## JOINT REGIONAL PLANNING PANEL (East)

JRPP No	<b>2015SYE006</b>
DA Number	<b>453/14</b>
Local Government Area	<b>North Sydney Council</b>
Proposed Development	<b>Demolition of existing building and construction of mixed use building consisting of 61 apartments, retail and 39 car-spaces</b>
Street Address	<b>231 Miller Street North Sydney</b>
Applicant/Owner	<b>Klimbe Pty Ltd</b>
Number of Submissions	<b>13 to original plans 3 to amended plans</b>
Regional Development Criteria (Schedule 4A of the Act)	<b>Capital Investment Value &gt; \$20M</b>
List of All Relevant s79C(1)(a) Matters	<b>North Sydney LEP 2013 - Zoning – B4 Mixed Use North Sydney DCP 2013 S94 Contribution SEPP 65 SEPP 55 - Contaminated Lands SREP (2005)</b>
List all documents submitted with this report for the panel's consideration	<b>Plans Lightwell opinion from Consultant Steve King Draft Conditions</b>
Recommendation	<b>Refusal</b>
Report by	<b>Geoff Mossemeneer, Executive Planner, North Sydney Council</b>

**Assessment Report and Recommendation**

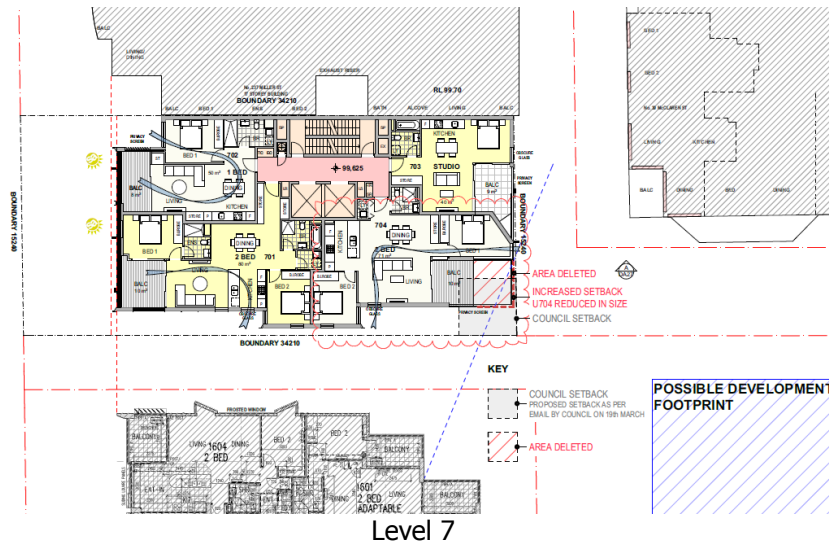
*Setbacks in south eastern corner not supported above level 7 difficult to support borrowing of setbacks from other sites. Council normally requires minimum setback of tower above podium of 3m from boundary as well as consideration of RDC. Need to increase setback at levels 7 -10 to a minimum 4m x 4m (square setback) at SE corner. Need to increase setback at levels 11 -17 to a minimum 6m x 6m (square setback) at SE corner. 3m setback from eastern boundary at level 15 and 16*

*The intention of the setbacks requested by Council is assumed to be to ensure appropriate setback from any future redevelopment of No. 229 Miller Street and to potentially improve solar access to the existing building at No. 225 Miller Street, given the separation distances between the proposed building and the existing building at No. 225 Miller Street are satisfactory to ensure visual privacy and the privacy treatments on the proposed windows/balconies will ensure privacy to the existing building at No. 39 McLaren Street. Having these intentions in mind and considering the suggested square shaped increased setbacks at Levels 7-10 and 11-17, it was considered that an alternative shape would provide improved solar access to the existing building at No. 225 Miller Street without resulting in unacceptable separation distances to an assumed redevelopment at No. 229 Miller Street.*

*In order to demonstrate this, the amended plans identify both the requested "square shaped" additional setback in grey shading and the actual increased setback area in red hatching. At Levels 7-10 the area reduced provides for a greater setback from the southern boundary than required but a smaller one from the eastern boundary, which actually results in a greater overall setback area, but more importantly a greater depth of setback from the southern boundary. As the point where the shadows are cast by the building is the south-eastern corner, the additional setback of this point of the building towards the north results in a more significant shadow improvement than the suggested setback area whilst having no significant difference in separation to a future development at No. 229 Miller Street and maintaining a suitable level of privacy to No. 225 Miller Street by the use of a privacy screen.*

*For Levels 12-17, the setbacks sought from the eastern boundary have generally been provided and an increased setback at the south-eastern corner is provided from both the southern and eastern boundaries, improving sunlight penetration into the building at No. 225 Miller Street. However, the extent of setback requested by Council has not been provided in full for a number of reasons including that the resultant change in solar access between what was requested and what was proposed was negligible and that the separation provided to a likely future development at No.229 Miller Street was acceptable. Given the acceptable impacts of the alternate design, a lesser setback was chosen as it results in a more appropriate architectural resolution of the eastern façade of the building and a more appropriate internal floor plan for the apartments in question.*

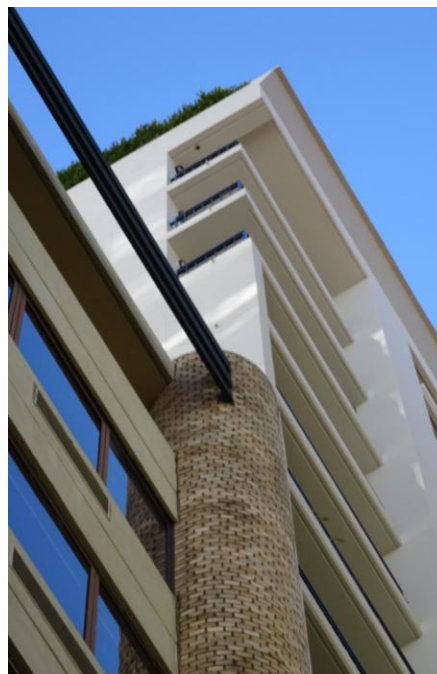
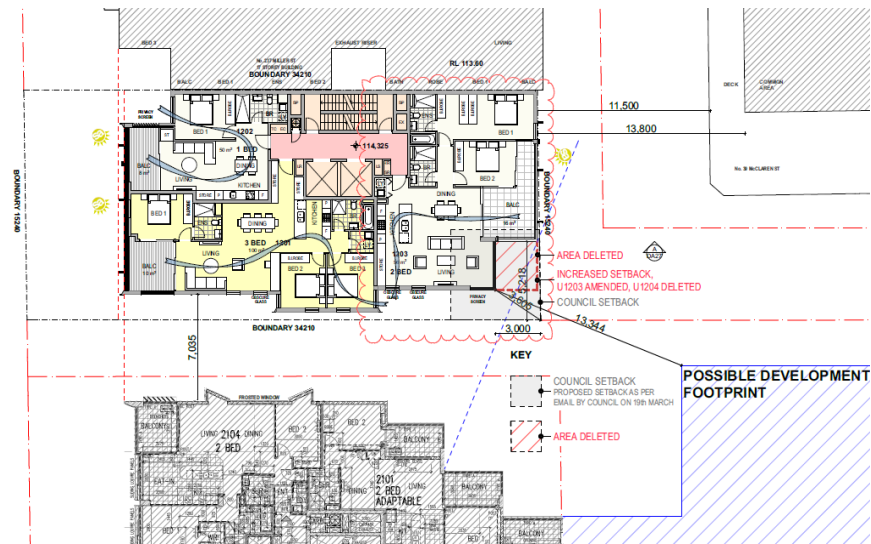
The adjoining property (No.237) has 3 open ended balconies at the front and rear on the northern boundary (adjacent to proposed levels 11, 12 and 13). The front balconies have an outlook over Miller Street and their sight line will be interrupted by the proposed building built to the building setback (5m) so a further setback is not warranted. The rear balconies however have a limited outlook and would benefit from levels 11 to 14 having a 1.5m setback from the eastern boundary (in addition to the setback from the northern boundary discussed below).

This will result in less shadow over 225 Miller Street (see shadow diagrams below) as well as increase in separation distances to No.39 McLaren Street. The need to increase setback at levels 11 -17 to a minimum 6m x 6m (square setback) at SE corner and 3m setback from eastern boundary at level 15 and 16 is still considered necessary for an acceptable amount of separation and to further reduce overshadowing. The separation

distances are to achieve visual and acoustic privacy. Heavy screening may assist visual but additional setbacks will improve acoustic privacy.

Level 16

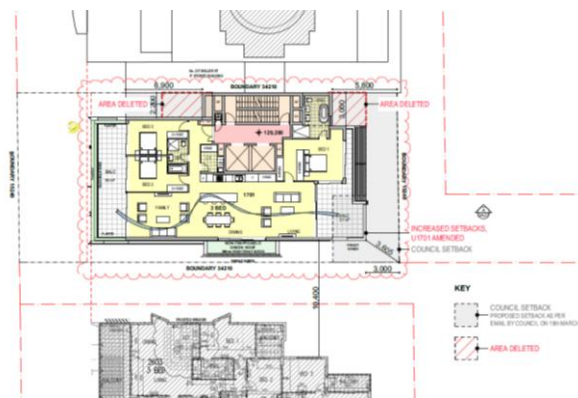
The proposed building does not provide for a setback from the light well of 237 Miller Street. This light well contains a bedroom window on each of the 14 levels facing east. The windows rely on the openness of the light well at the boundary for amenity.

## Shadow impacts

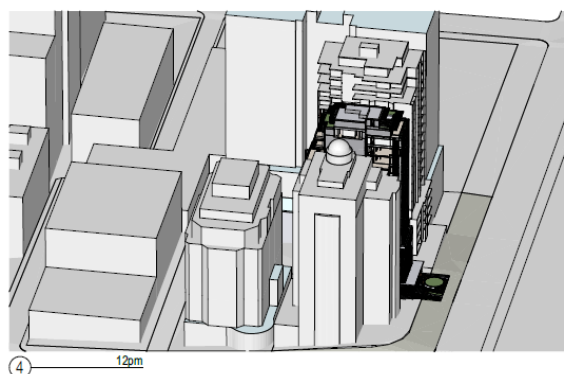
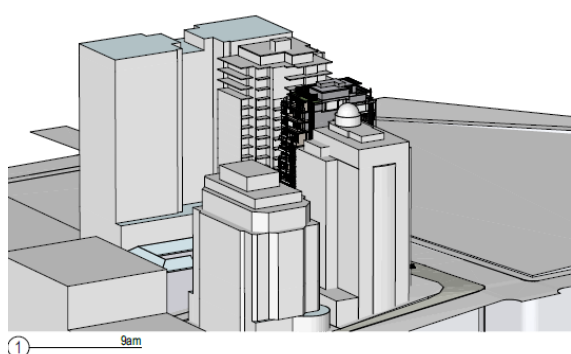
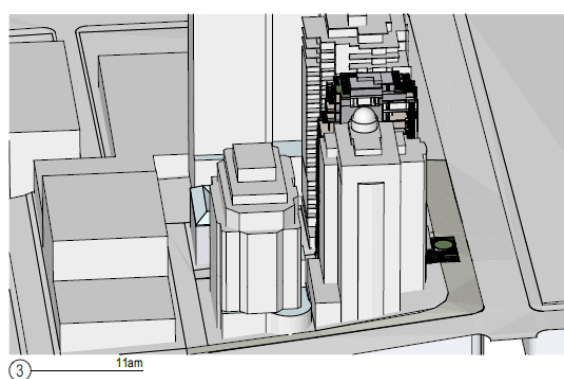
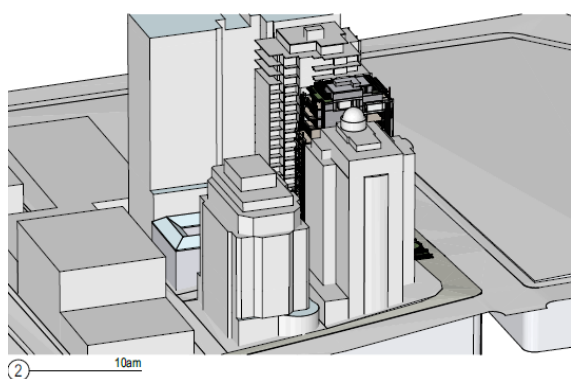
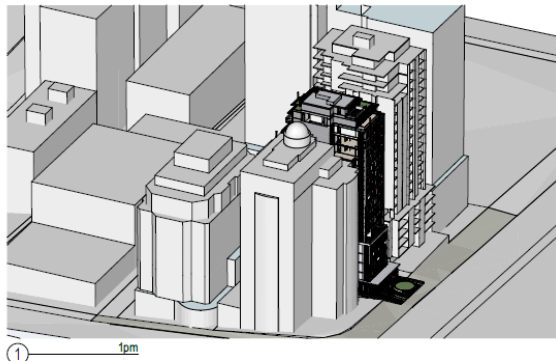
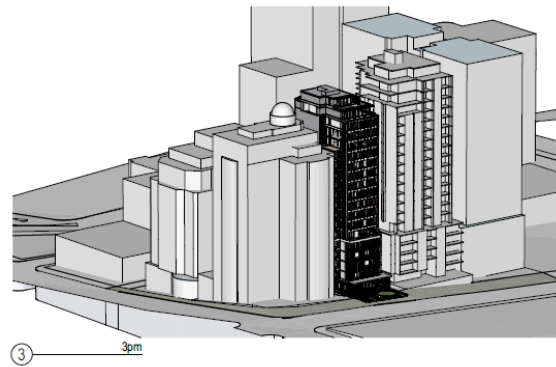
Sun's eye view shadow diagrams were requested to demonstrate the extent of shadow over 225 Miller Street and the areas of the proposed building that cause the shadow. It helps to show that the additional setbacks requested from level 11 up will improve impacts on the surrounding buildings between 9am and 12noon.

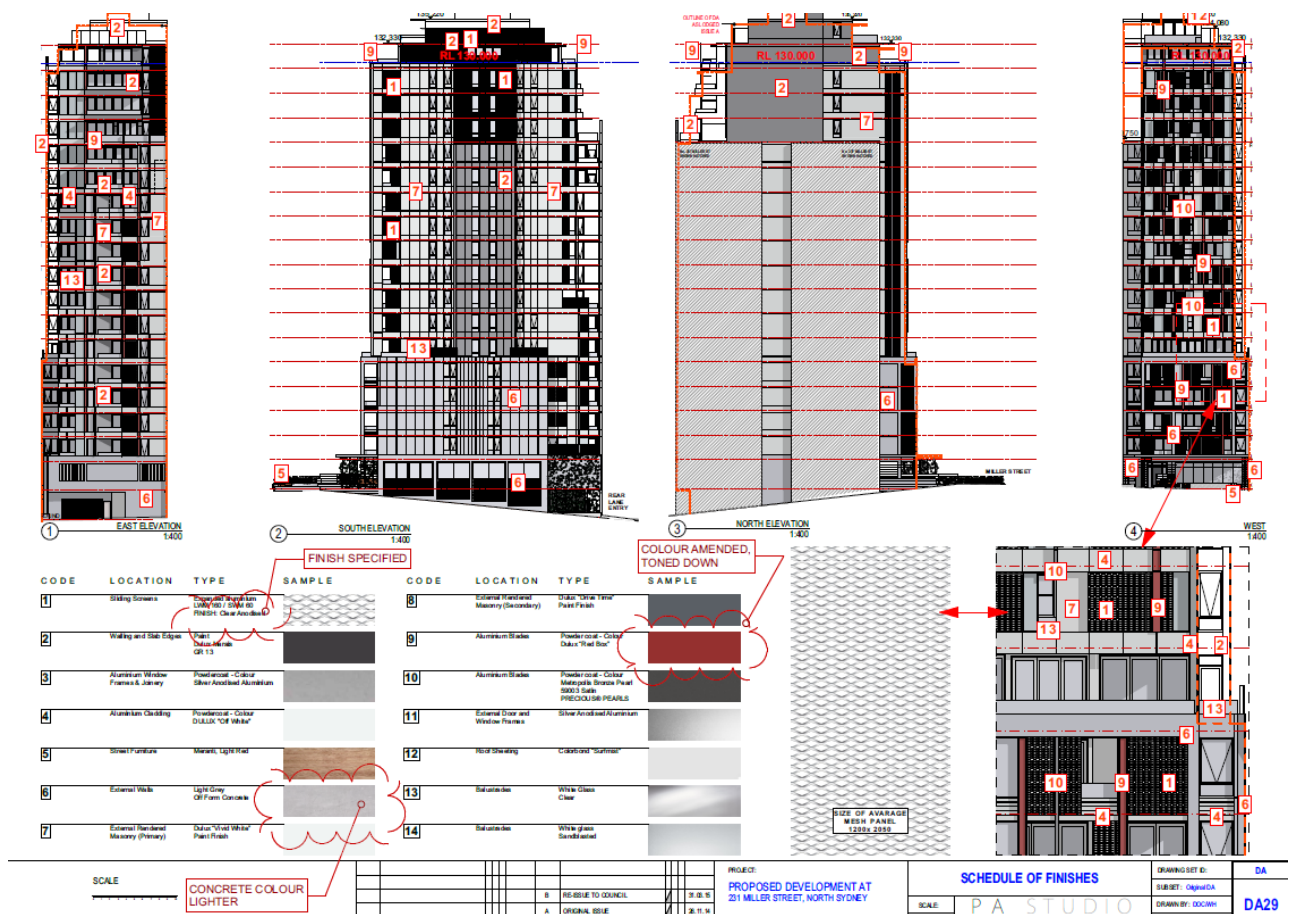
The Design Excellence Panel raised concern about the materials and finishes with regard to the dark colour of the podium base and red detailing, with more subtle treatment and colours suggested.

The proposed colours and materials have been reconsidered in light of these comments and an amended sample board has been prepared. The board shows that the expanded mesh aluminium screens are to be clear anodized and the colour of the podium to be made lighter.

There are no objections to the proposed materials.
